# Access Compliance Report

## Public Rights-of-Way

### (Curb Ramps)

Intersection ID: 28044	Main Street: TOM_SHORT_RD	Cross Street: ARDREY_KELL_RD	Location: SW
ADA ID: F3838803970A	Ramp Type: Para	Initial Pass/Fail: Fail	Overall Compliance: No
		Severity Score: 12.5

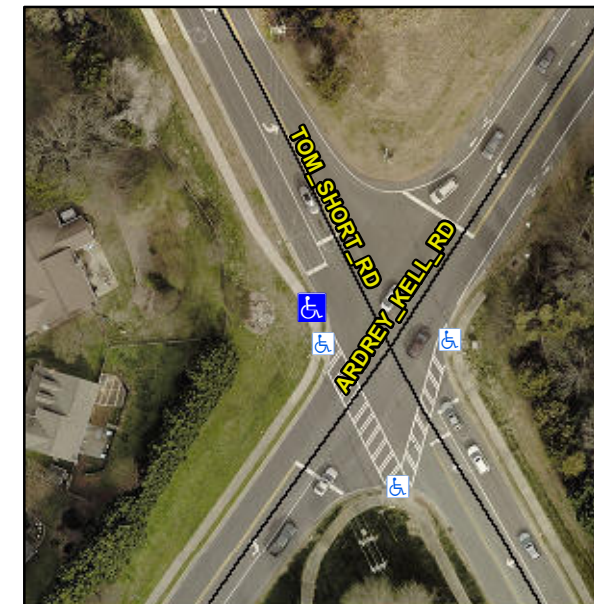
Surveyor Notes:

**RT RP < 5%**

PROW/ADA:

**R304.5.3**

Possible Solutions:

**Remove & Replace Entire Ramp.**
